JRPP Reference: 2013SYE105

Address of Site: 2-22 Birdwood Ave & 1-15 Finlayson Street, Lane Cove

Application Reference: DA 194/2013

Description of Proposal: Stage 1 Concept Plan for the redevelopment of the site for the purpose of 4 residential flat buildings, basement parking and on-site landscaping

Drawing Title
Building Envelope Plan

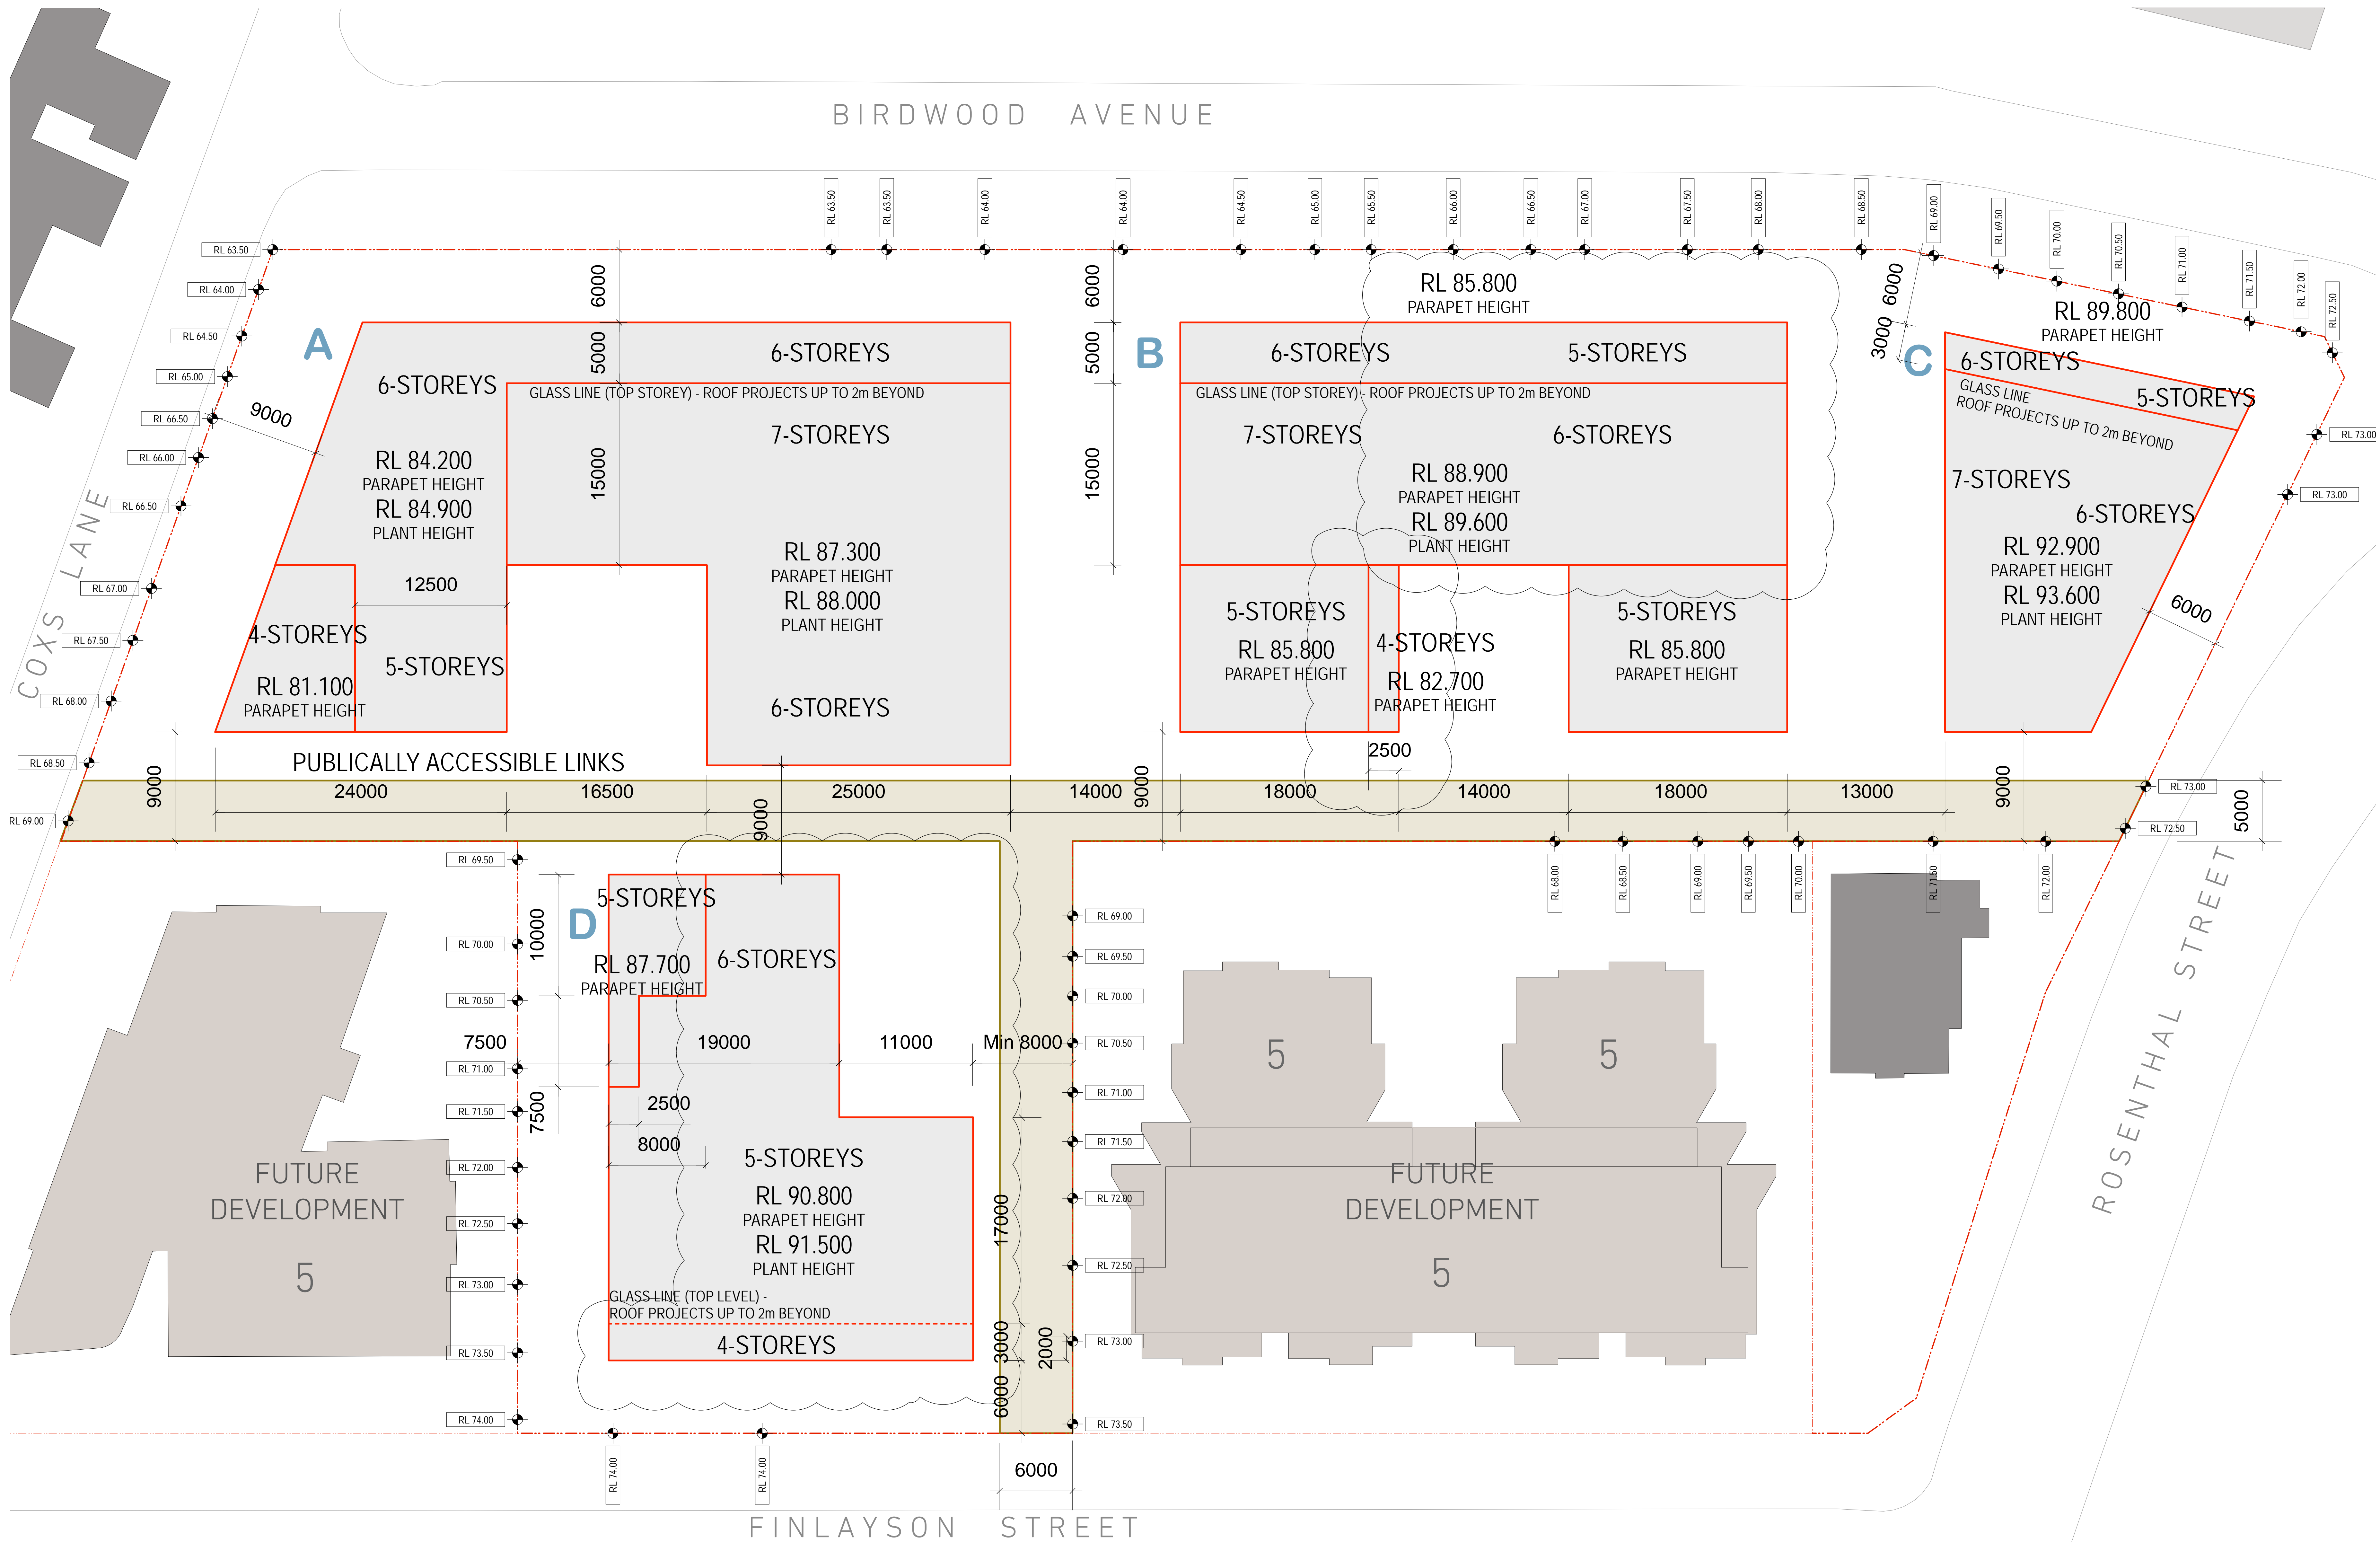
S2	20/03/14	kg	Building D and E modified
S1	15/11/13	kg	Stage 1 DA Submission
Rev	Date	Approved by	Revision Notes
Scale		Project No	
1:200	@B1, 40% @A3	13043	Drawn by ds
Scale		Dwg No	Rev S2
FOR INFORMATION		MP_100-001
